**Addendum No. 2**  
**November 27, 2024**

**Project: SIOUX FALLS CAREER & TECHNICAL EDUCATION ACADEMY'S AGRICULTURE  
& CARPENTRY ADDITION PROJECT PD #3471**

Architect: Architecture Incorporated

REFLECTED CEILING PLANS

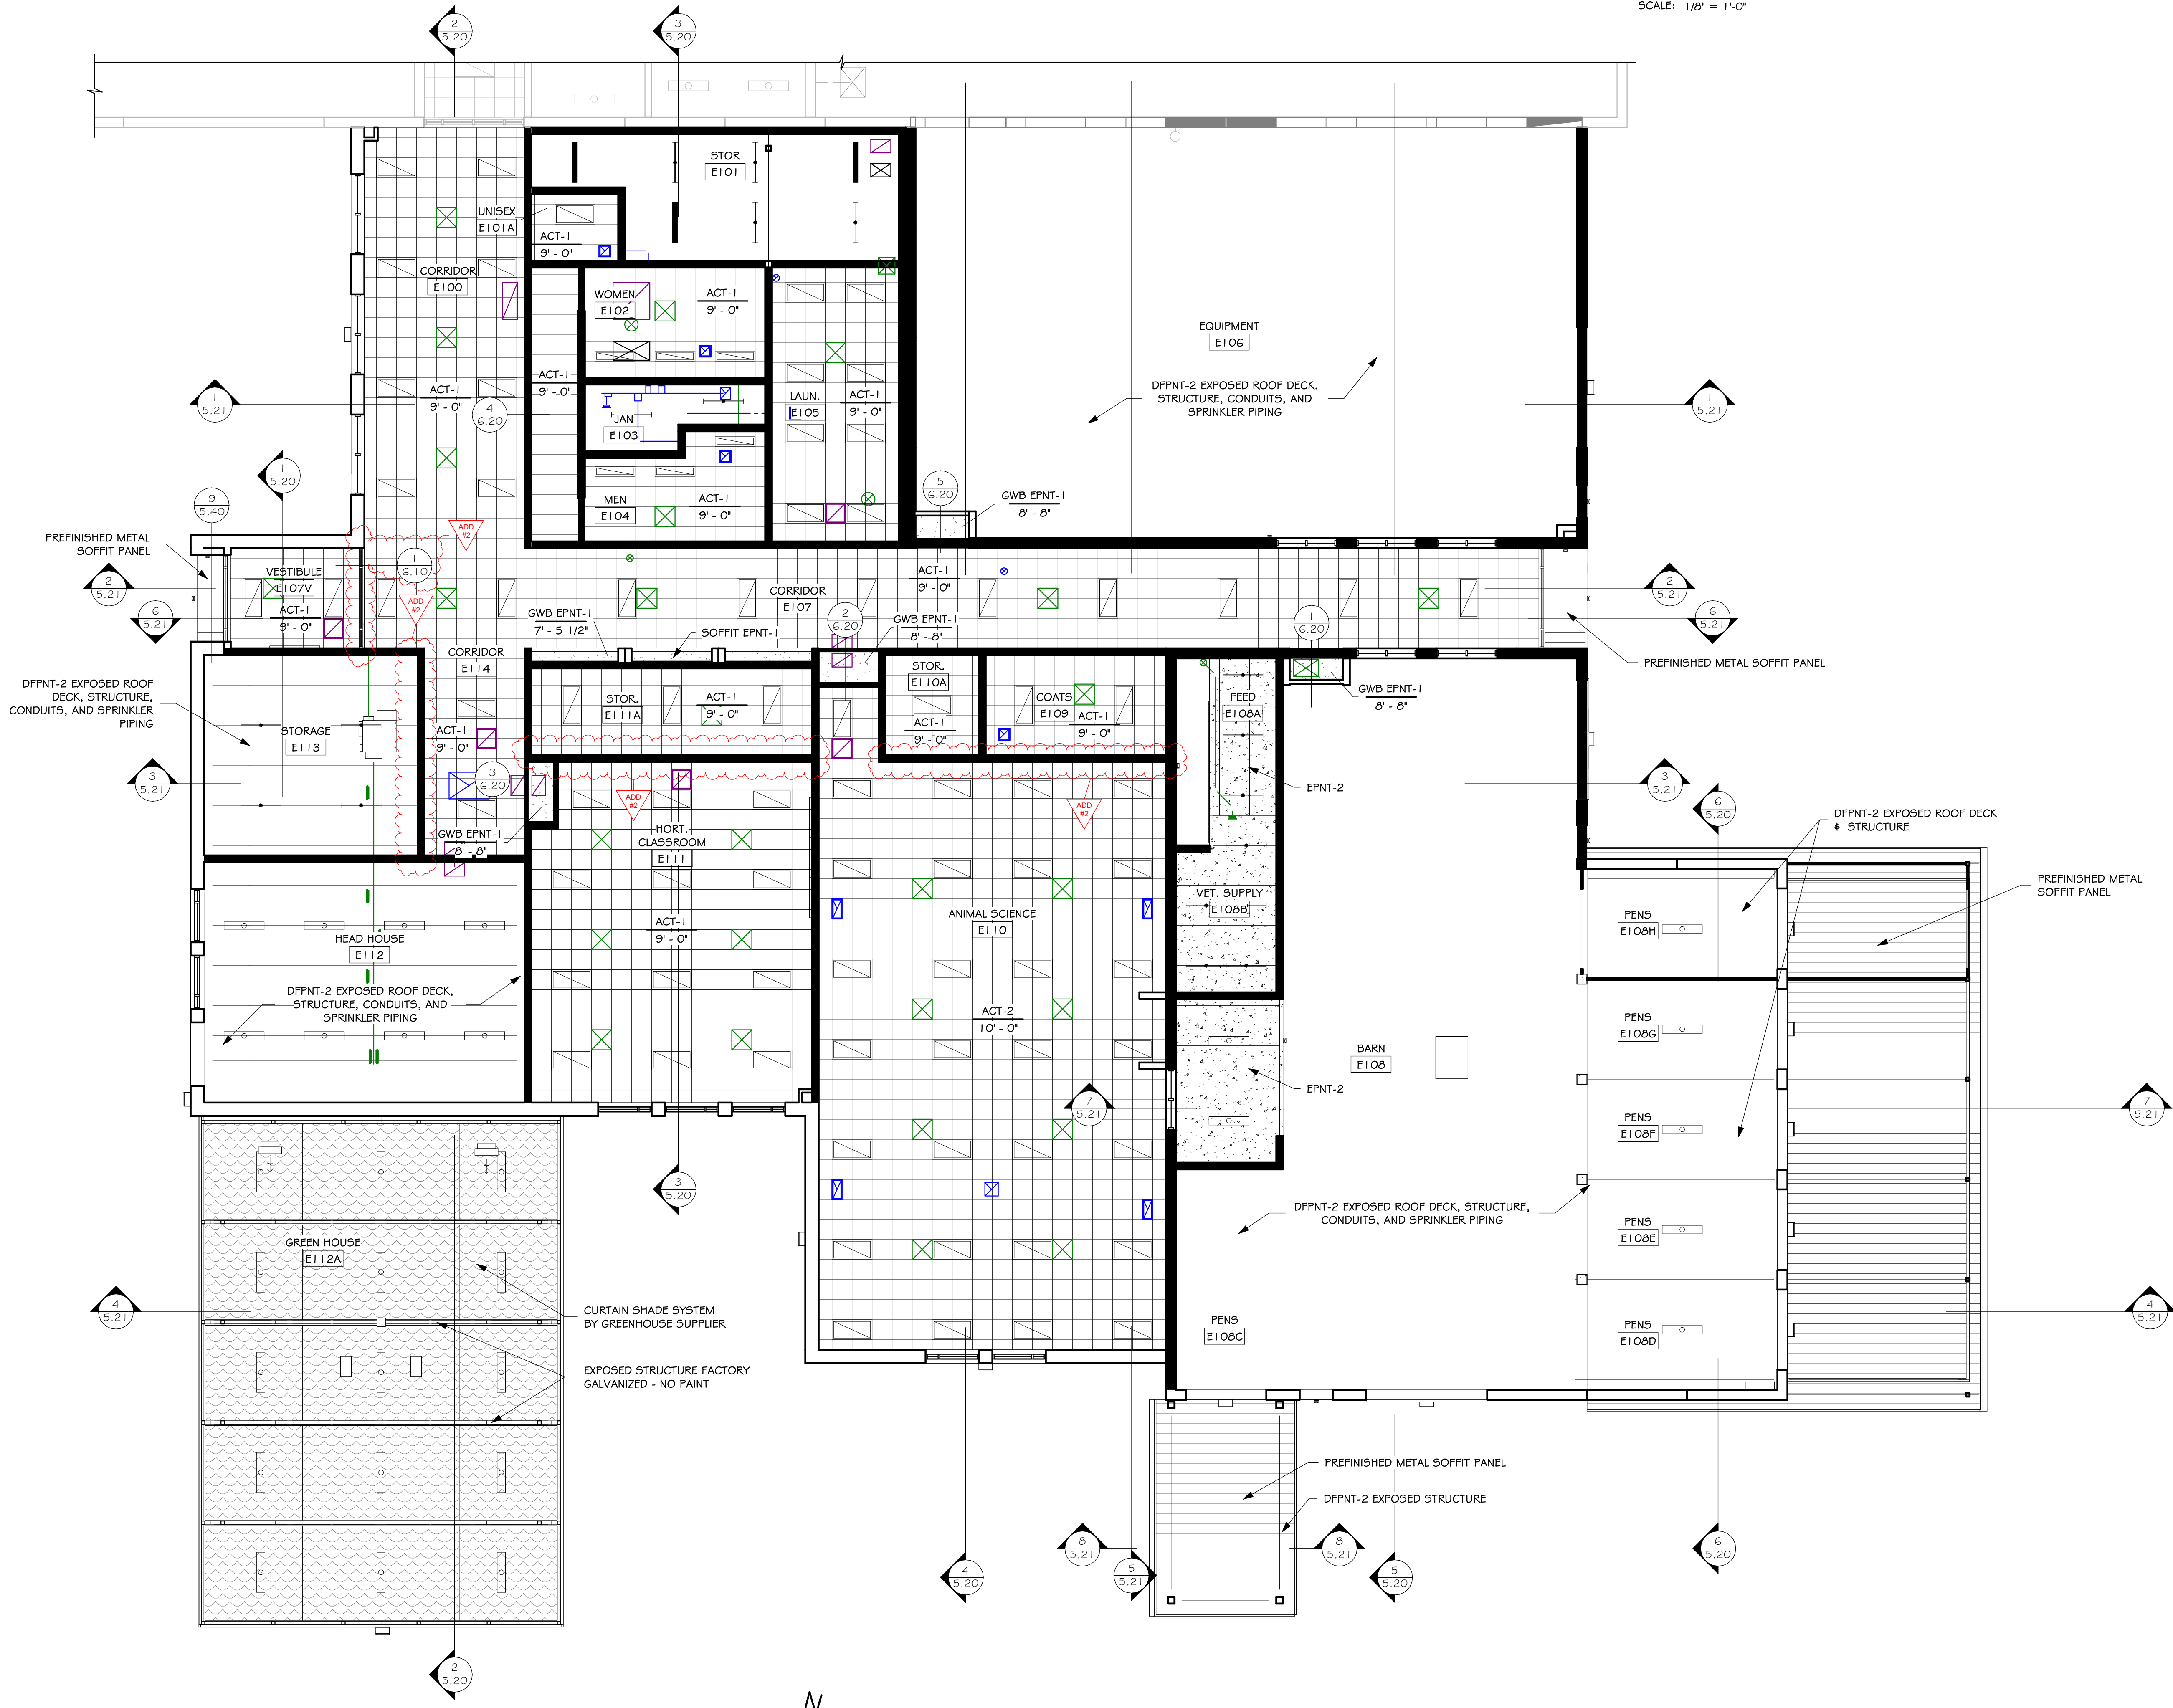
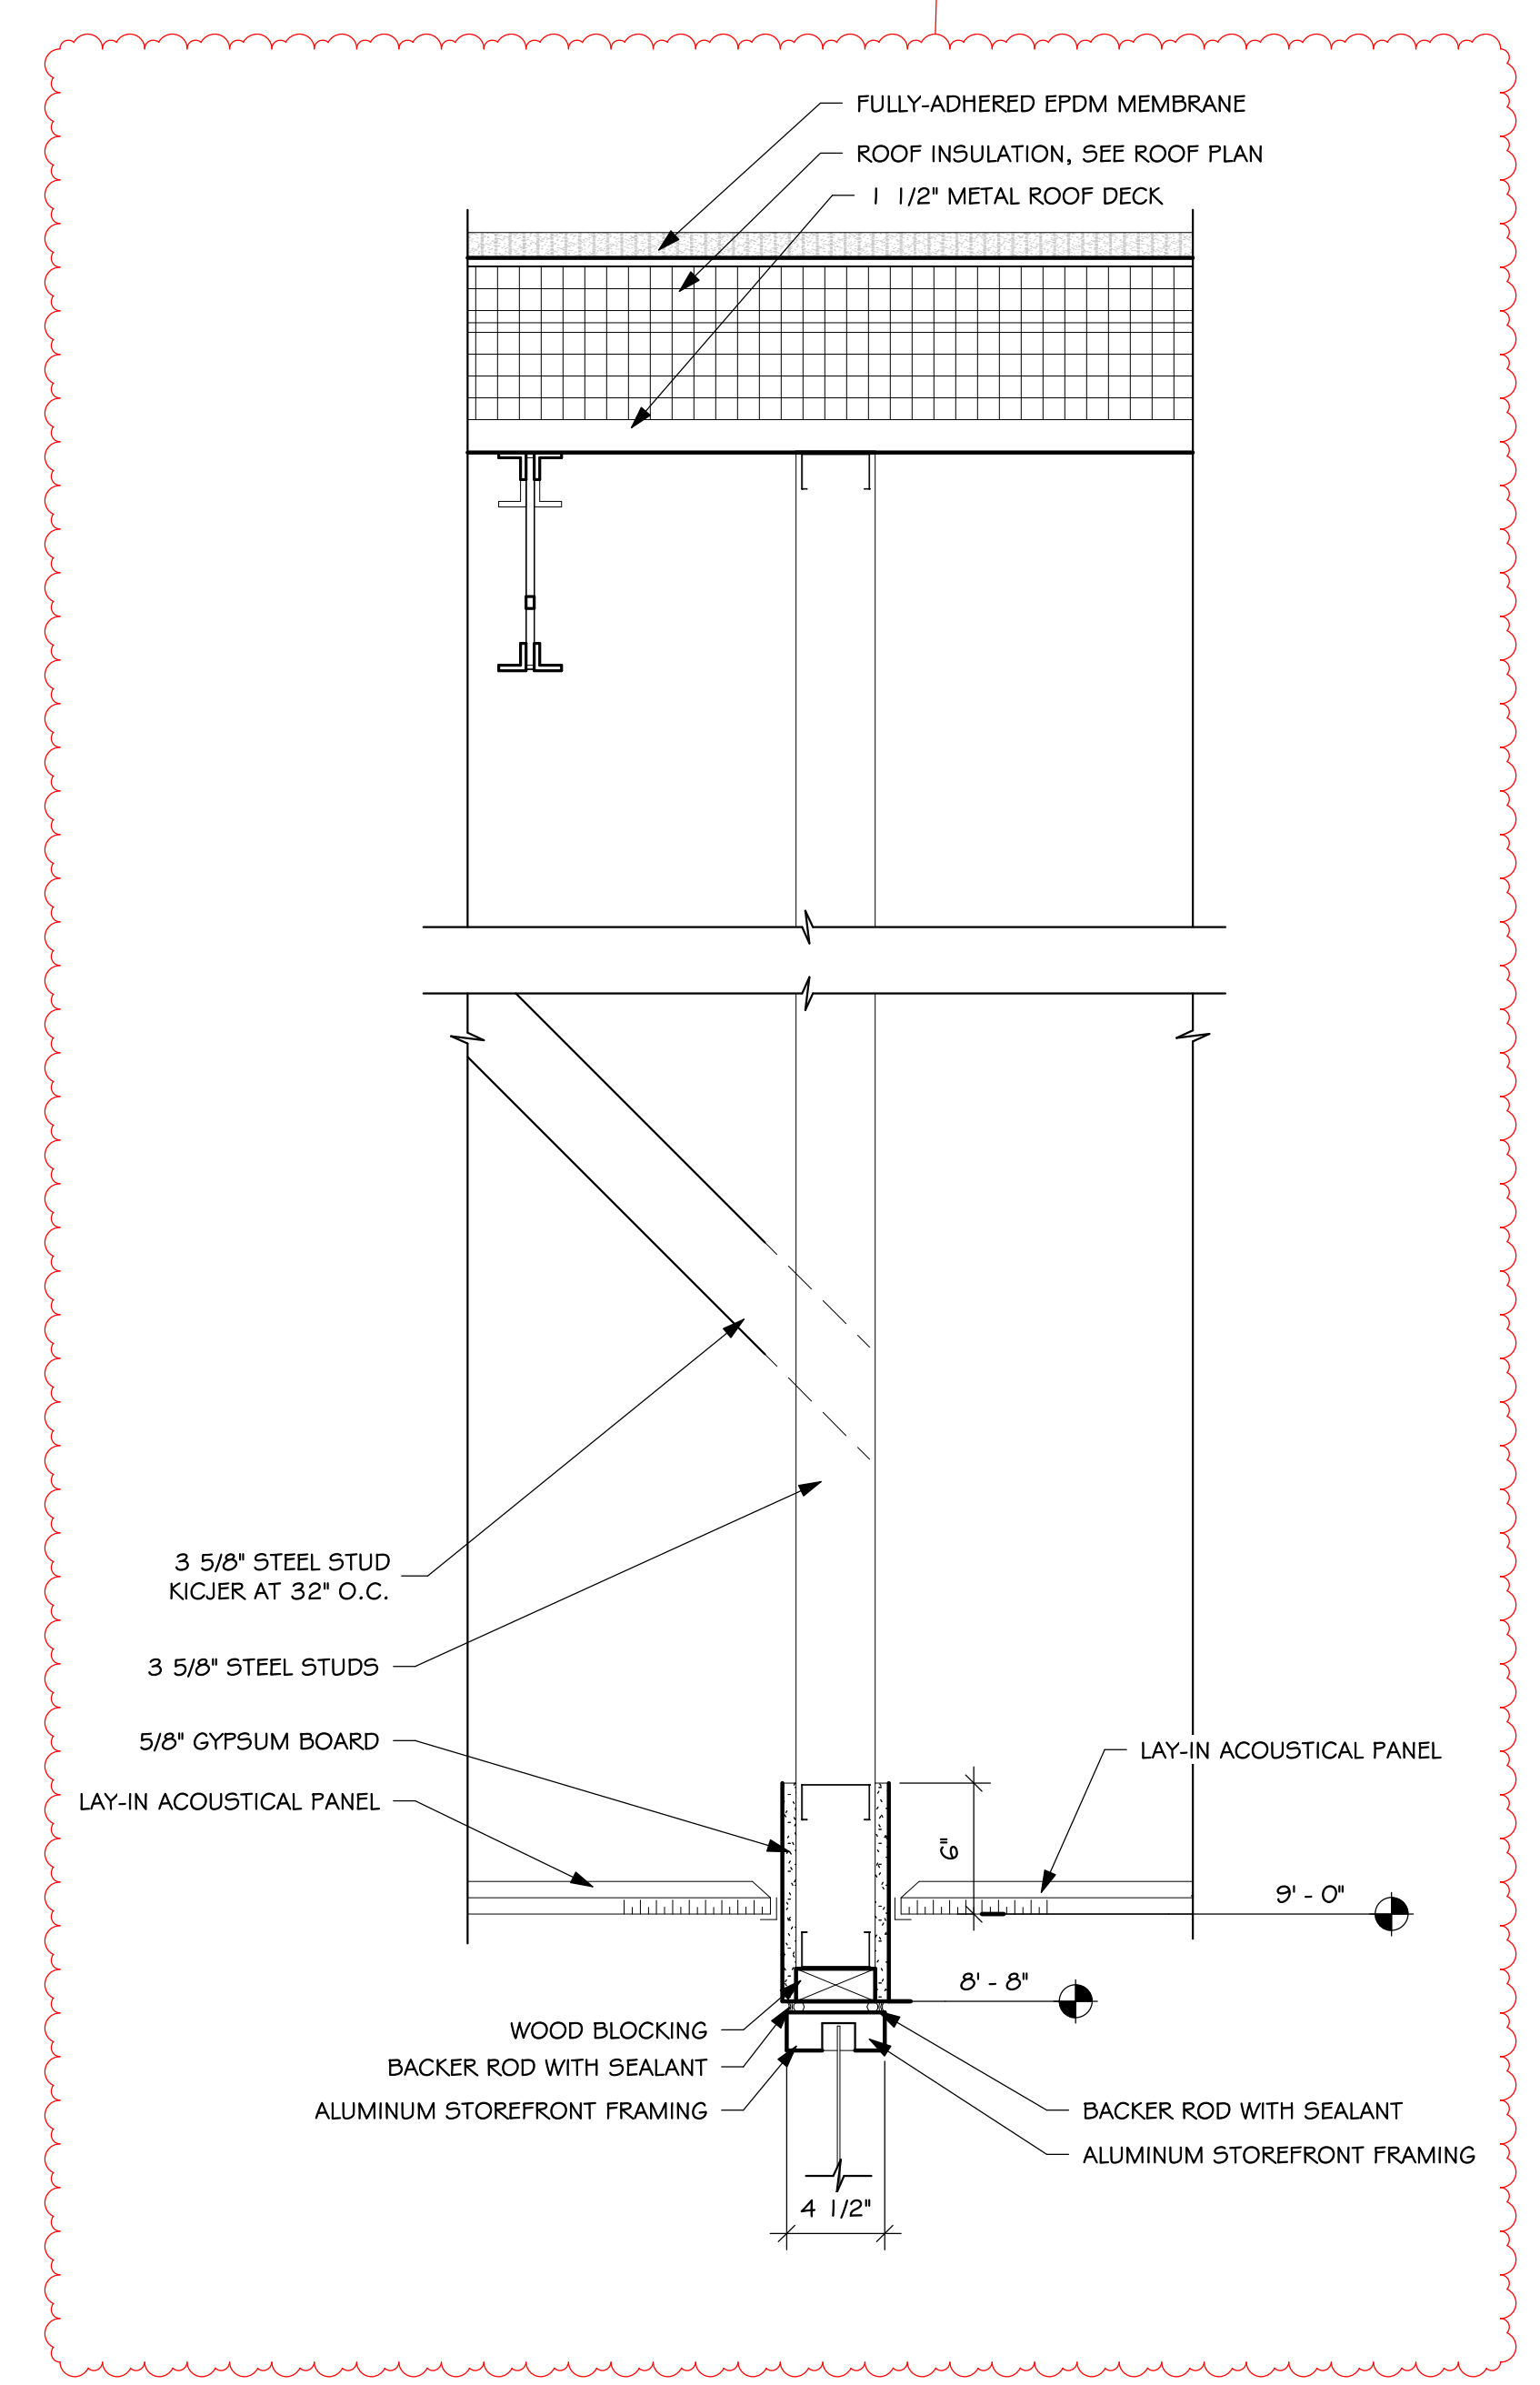
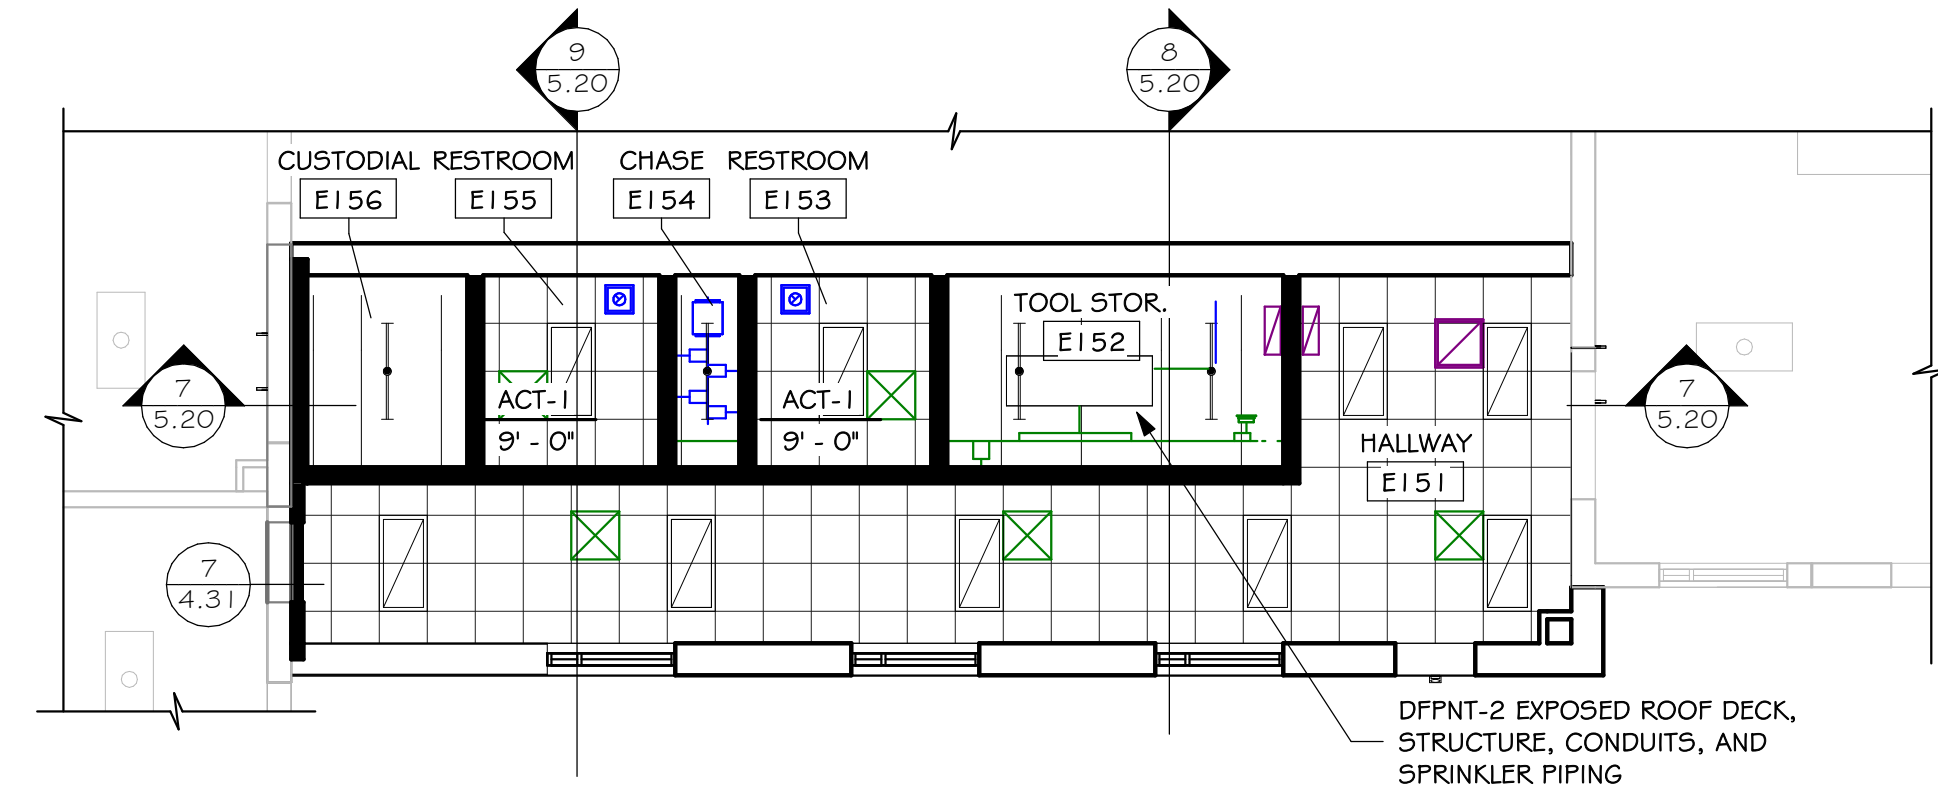
- a) Reference (attached) *revised* drawing Sheet 6.10, revision dated 11-27-24, attached to the end of this addendum for the following:
  - i) The masonry wall that occurs between Animal Science E110 and Coats E109 / Storage E110A shall extend up to and be sealed to the underside of the roof deck.
  - ii) The masonry wall that occurs between Horticulture Classroom E111 Storage E111A shall extend up to and be sealed to the underside of the roof deck.
  - iii) The masonry wall that occurs between Storage E113 and Corridor E114 shall extend up to and be sealed to the underside of the roof deck.
  - iv) Reference *new* detail 1/6.10 for the head detail at door E107V-2.

SD-1  
 REF SHEET:  
 4.10A

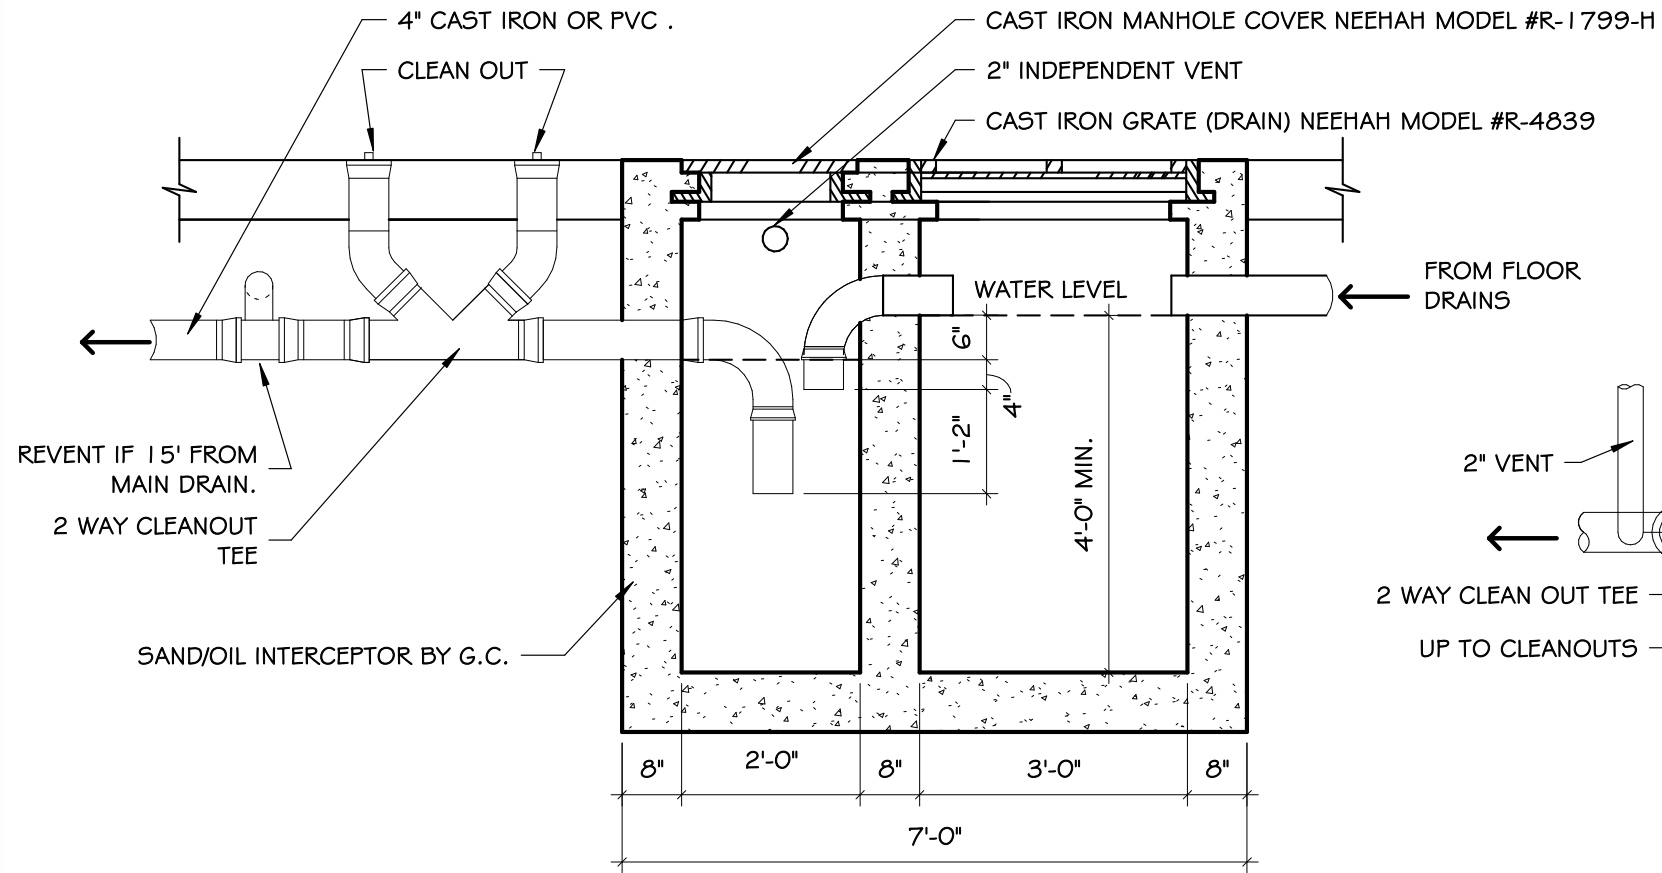
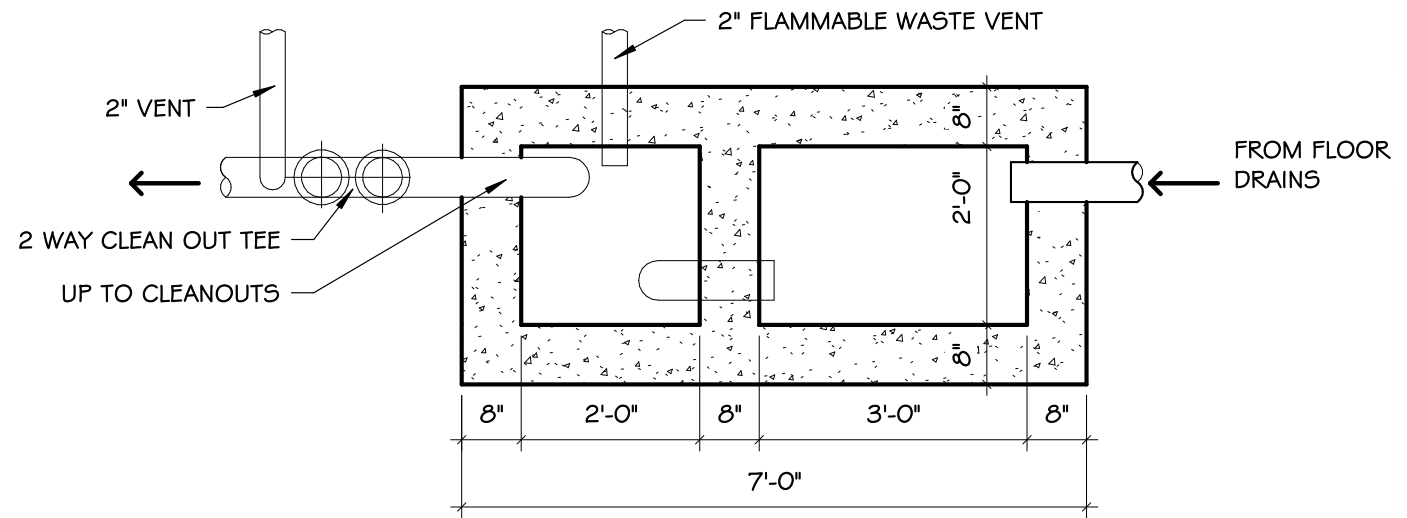
- d) The Contractor shall include furnishing and installing a 1.5” OD single steel pipe detectable cane rail beneath the stair stringer in Feed E108A. Length: 7’-6”. Height: 24” A.F.F. to top of pipe. Assembly to be bolted to floor.
- e) Reference (attached) *supplemental* drawing SD-1, dated 11-27-24, attached to the end of this addendum for additional information / details for the oil/sand interceptor in Equipment E106. Oil/sand interceptor to be furnished and installed by the General Contractor.
  - i) The interceptor may be cast-in-place or precast – Contractor’s option.
  - ii) Acceptable Precaster: Josten Concrete Product Company, Inc (Sioux Falls, SD).
